Date: **October 11, 1993**

Subject: **CORRECTING PICTURE SHADING**

Model: **BKM-2085-14/2085-20**
BVM-1310/1315/1910/1915

Figure 1

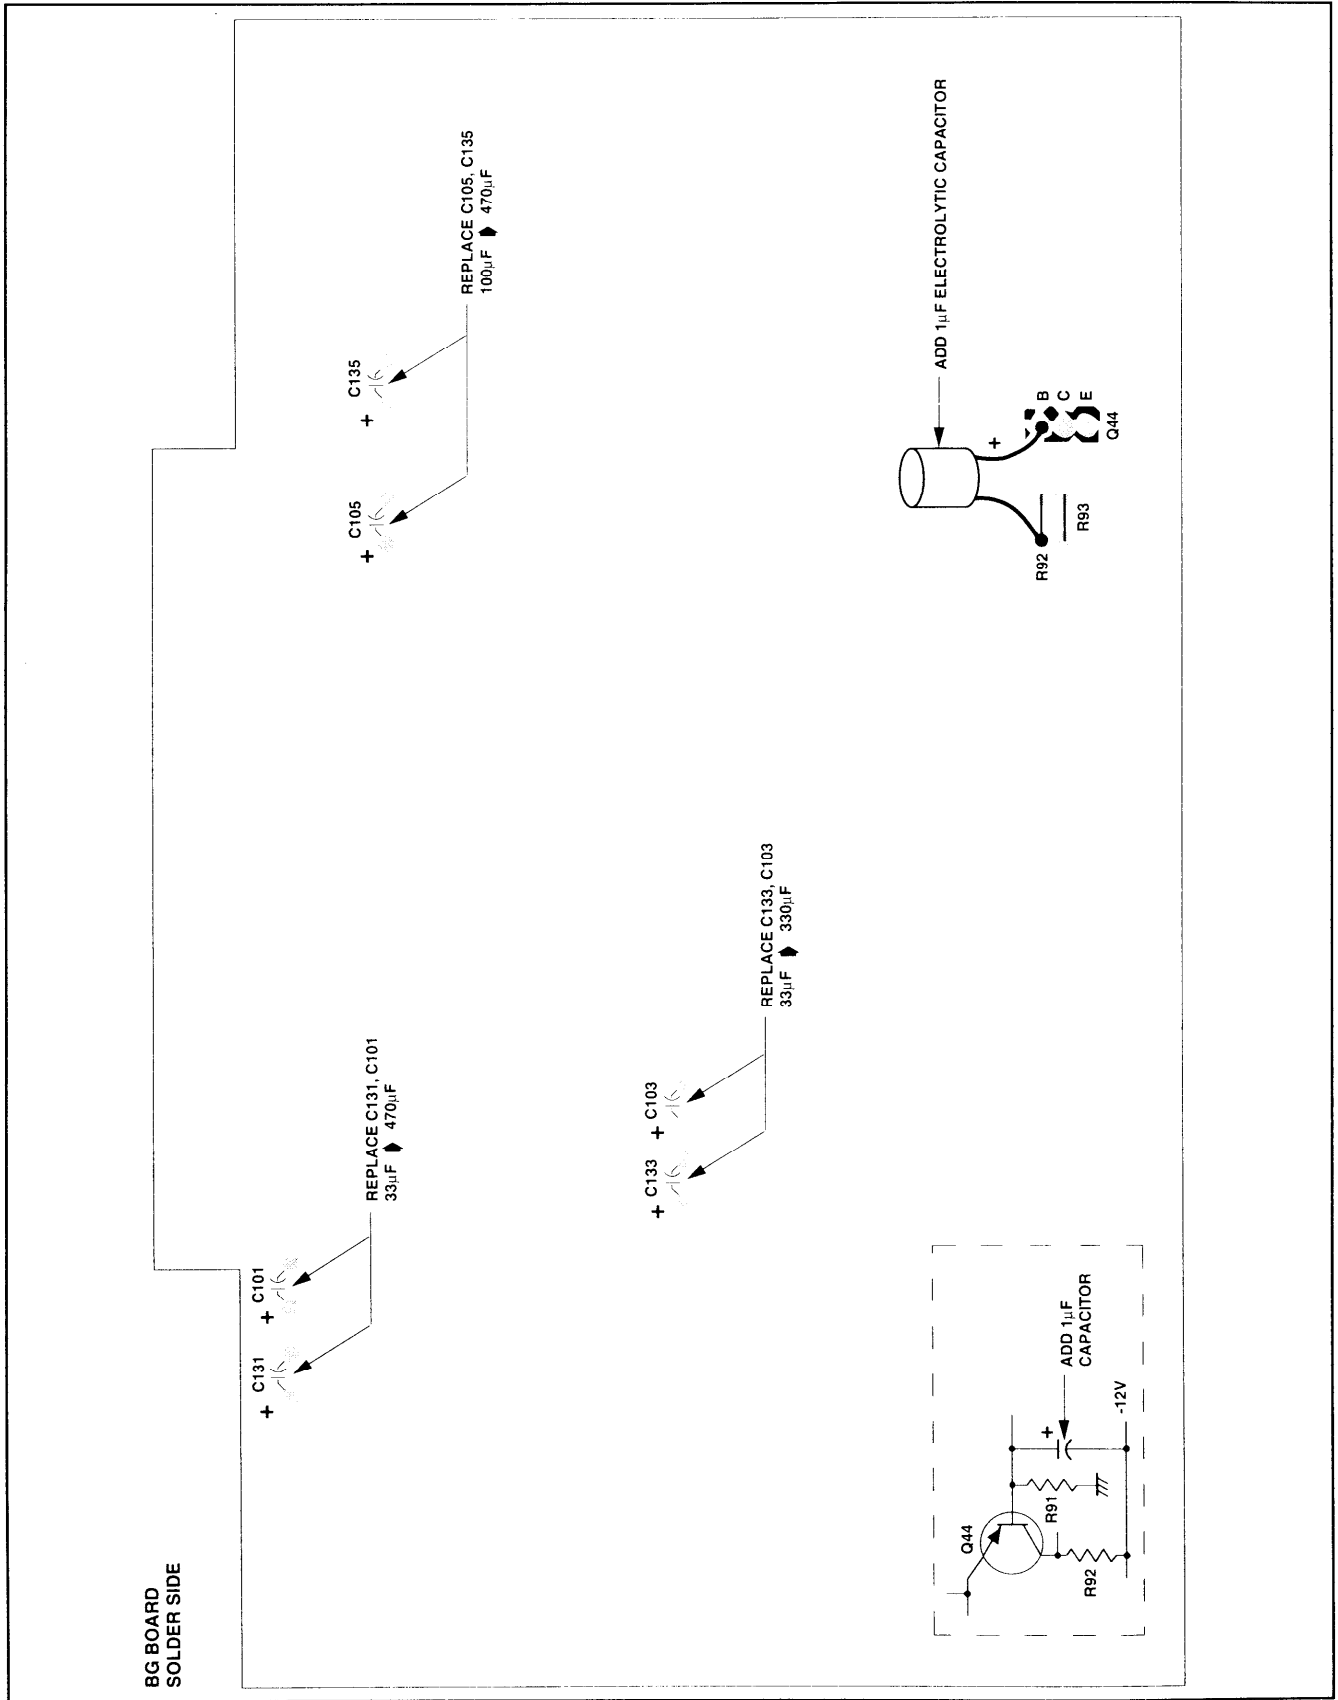
BG Board, Solder Side (See Figure 1.)

1. Replace the following capacitors with new 470 μ F electrolytic capacitors: C101, 105, 131, 135.

2. Replace the following capacitors with new 330 μ F electrolytic capacitors: C103, 133.
3. Solder a new 1 μ F electrolytic capacitor between base of Q44 and R92 (-12V).

Figure 2

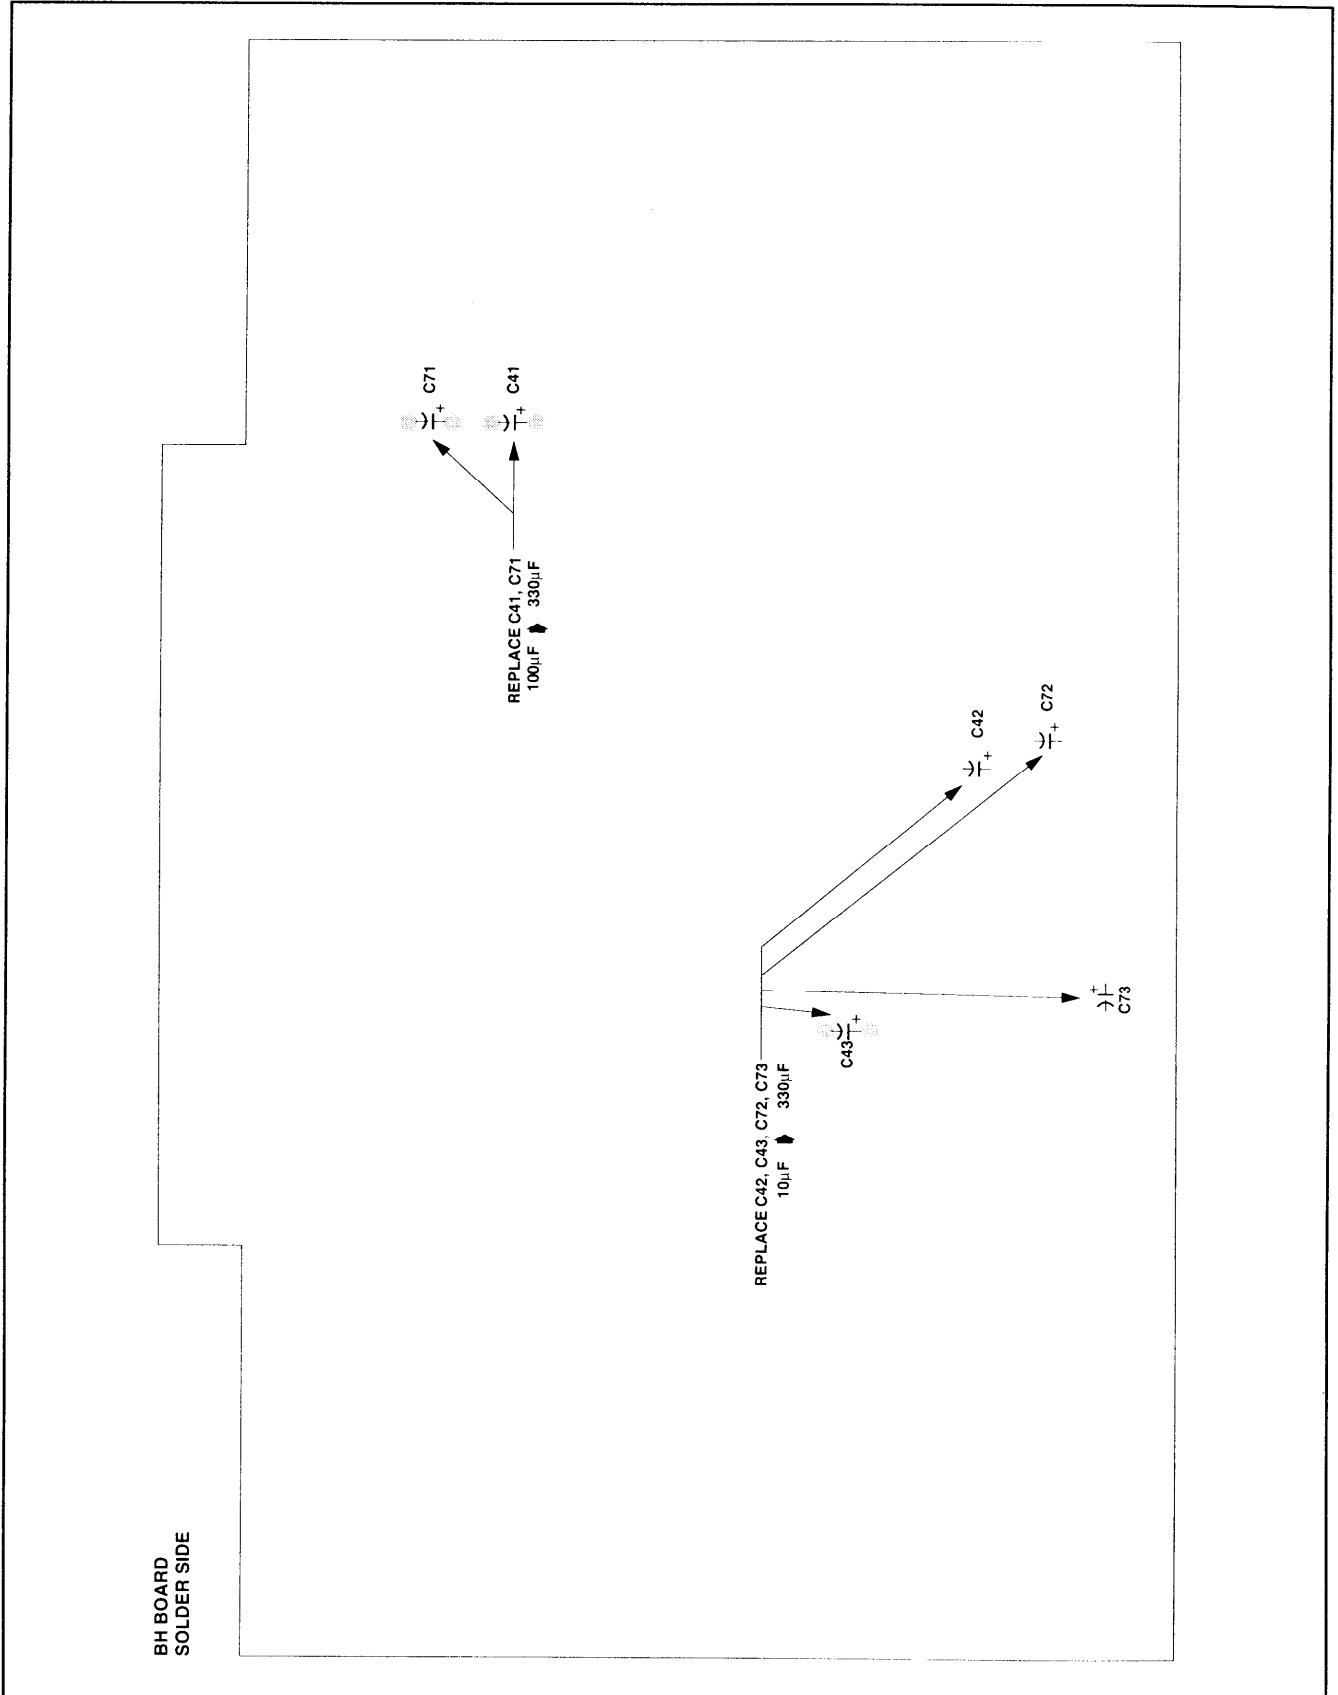
BH Board, Solder Side (See Figure 2.)

Replace the following capacitors with new 330 μ F electrolytic capacitors: C41, 42, 43, 71, 72, 73.

Figure 3

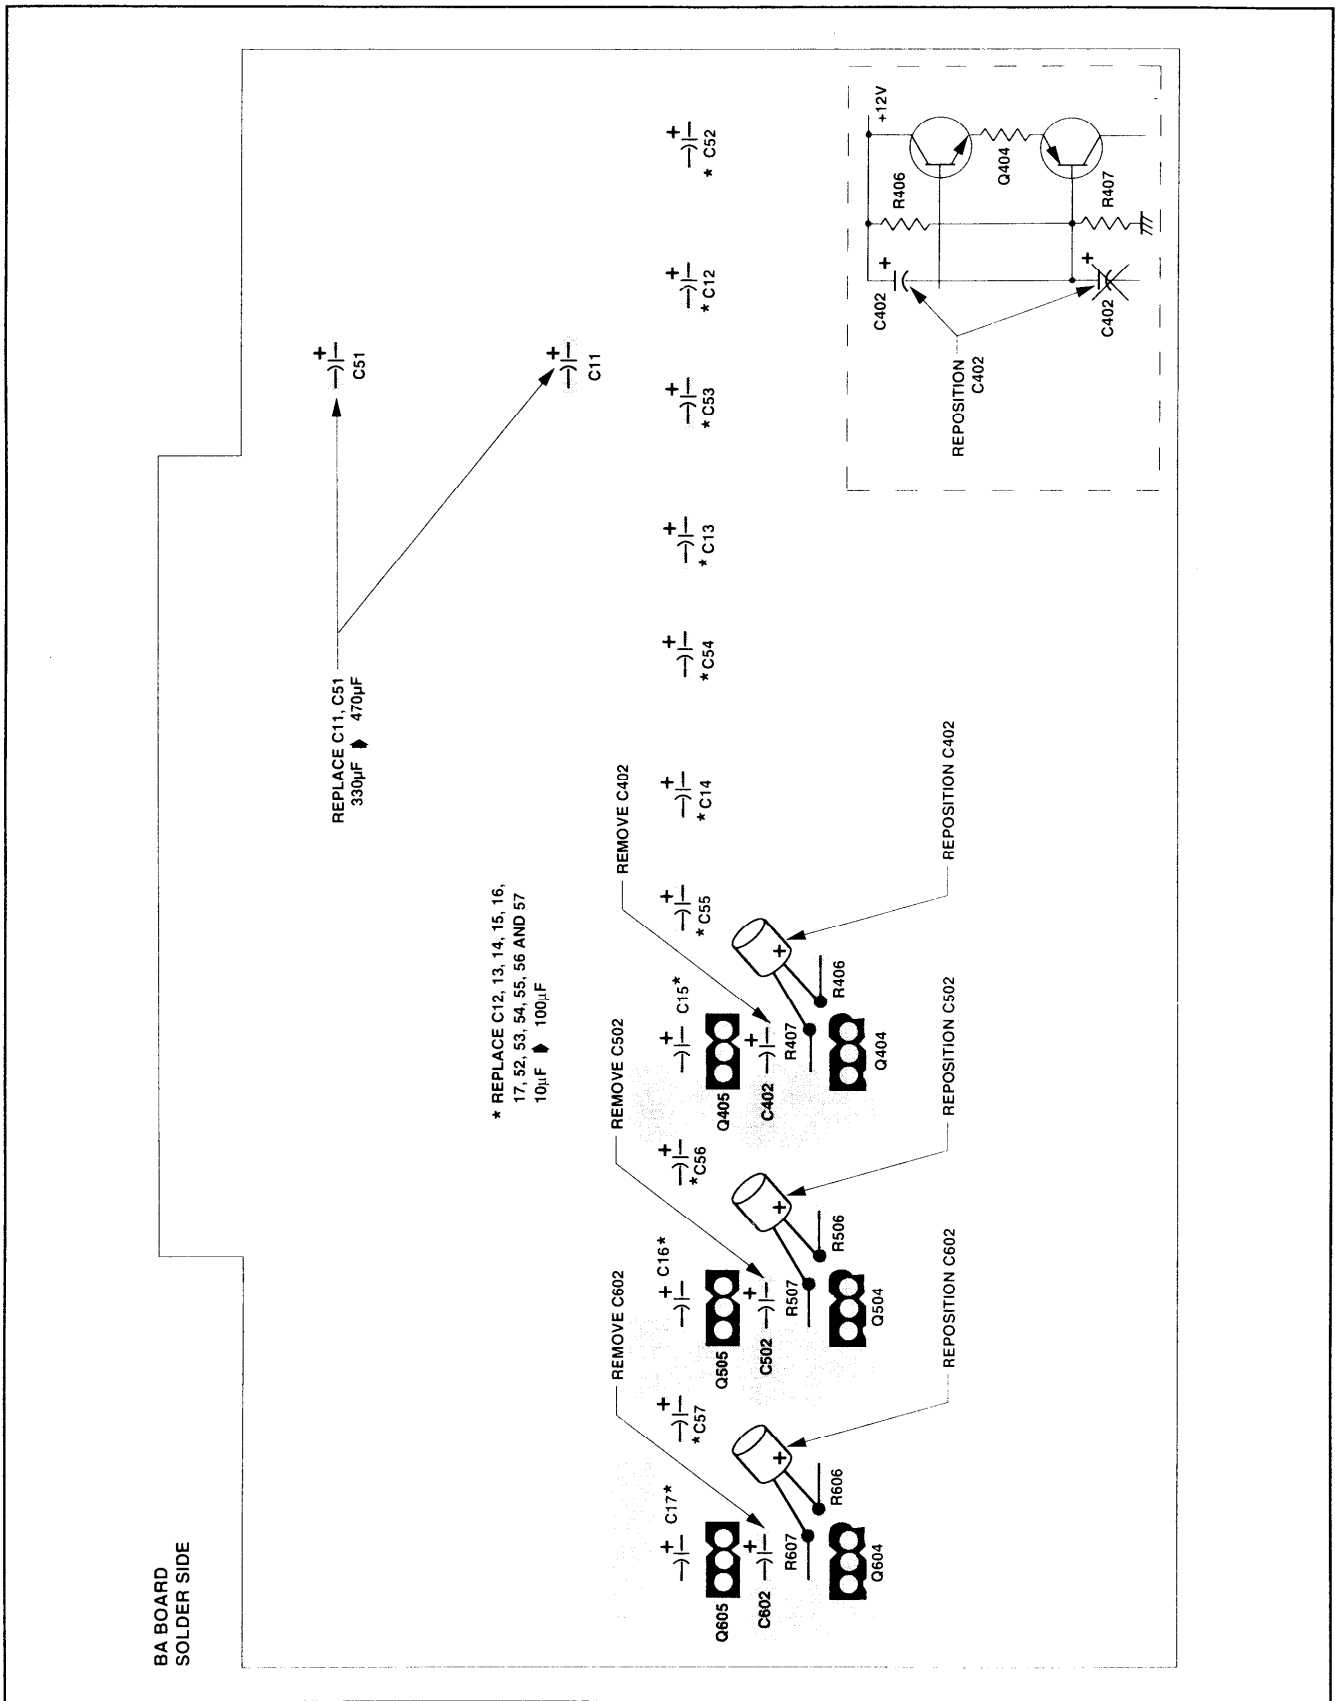
BA Board, Solder Side (See Figure 3.)

1. Replace the following capacitors with new 470 μ F electrolytic capacitors: C11, 51.
2. Replace the following capacitors with new 100 μ F electrolytic capacitors: 12, 13, 14, 15, 16, 17, 52, 53, 54, 55, 56, 57.
3. Reposition C402, C502, and C602 as shown in Figure 3.

Figure 4

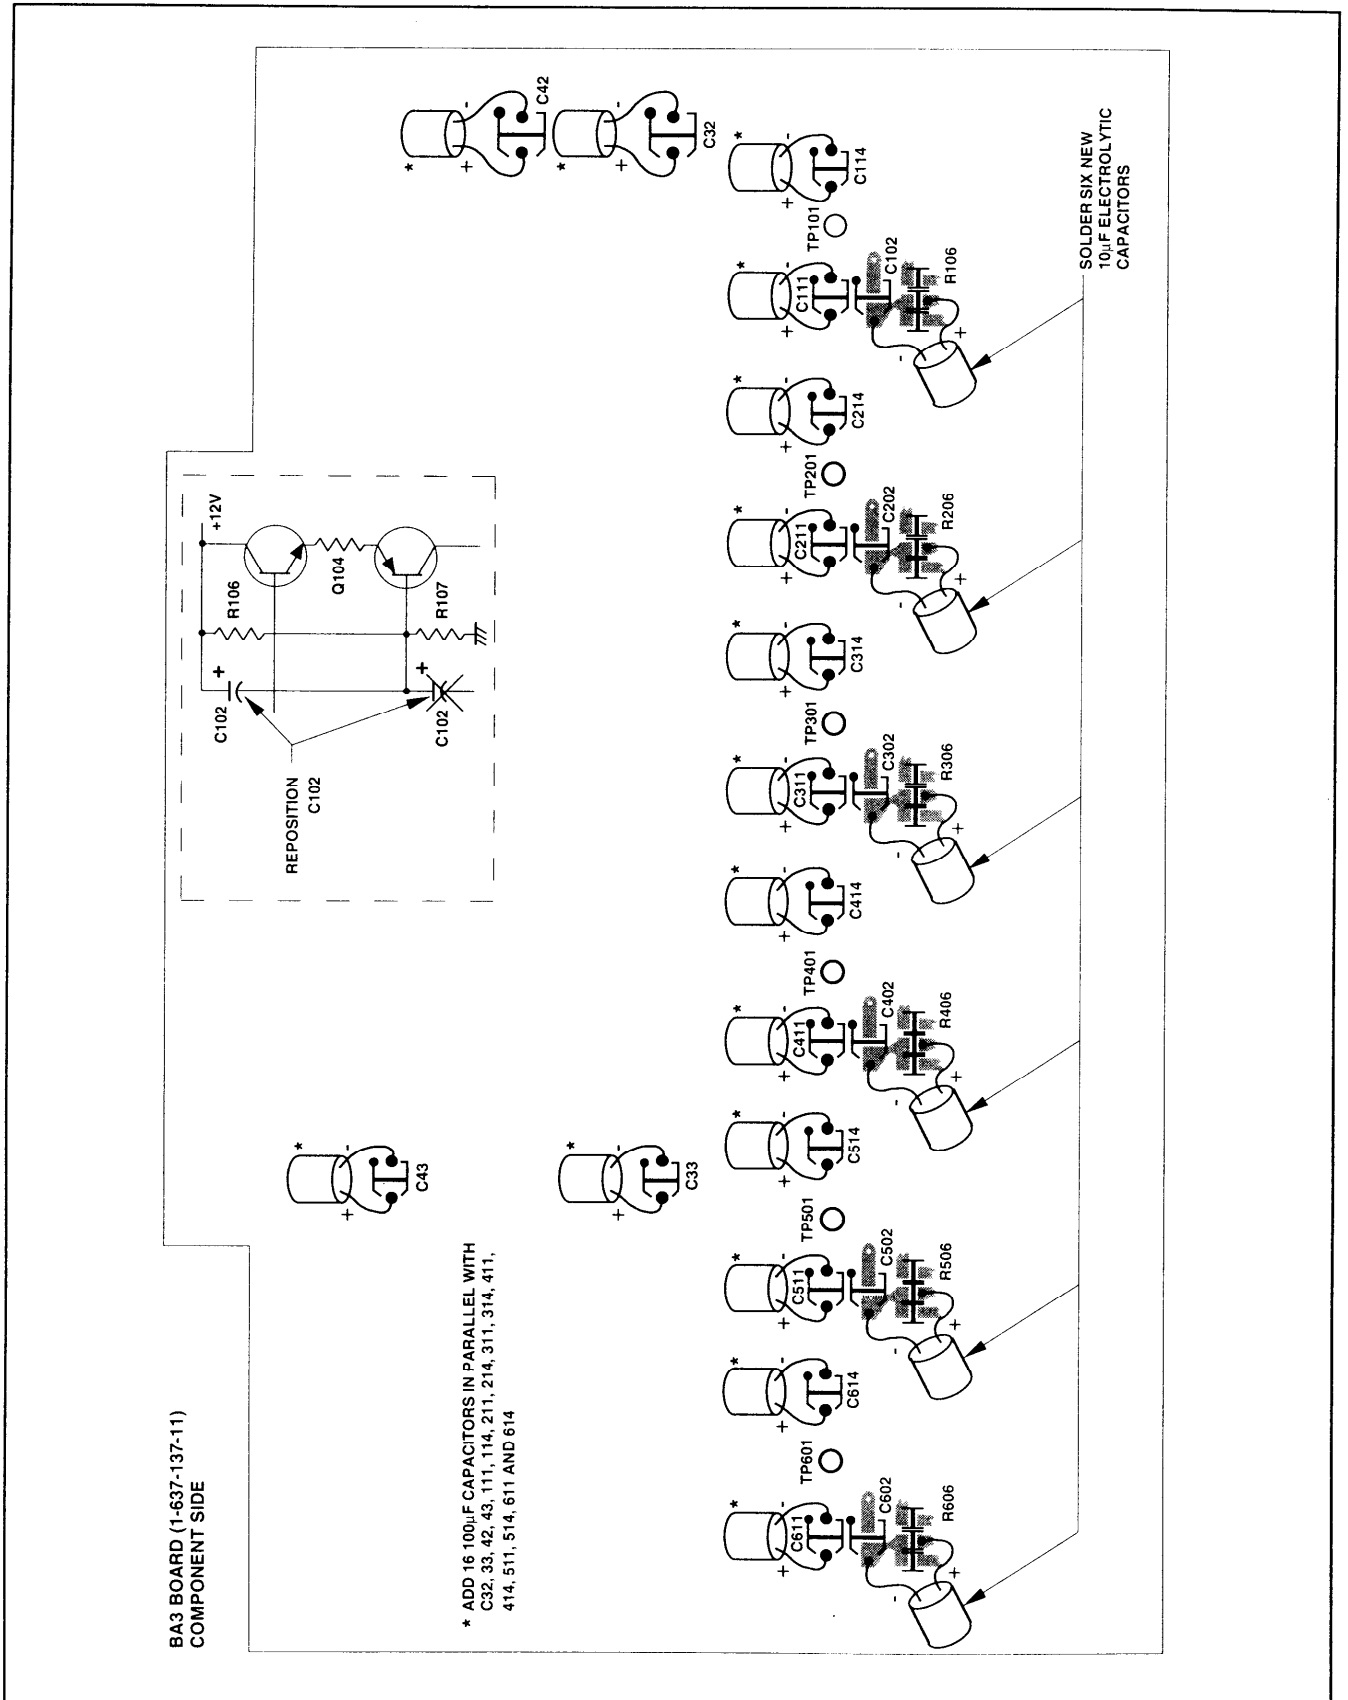
BA3 Board (1-637-137-11) Component Side (See Figure 4.)

1. Remove electrolytic chip capacitors C102, 202, 302, 402, 502, and 602.
2. Solder six new 10 μ F electrolytic capacitors at new positions shown in Figure 4.
3. Add 16 new 100 μ F electrolytic capacitors in parallel with the following existing capacitors: C32, 33, 42, 43, 111, 114, 211, 214, 311, 314, 411, 414, 511, 514, 611, 614.
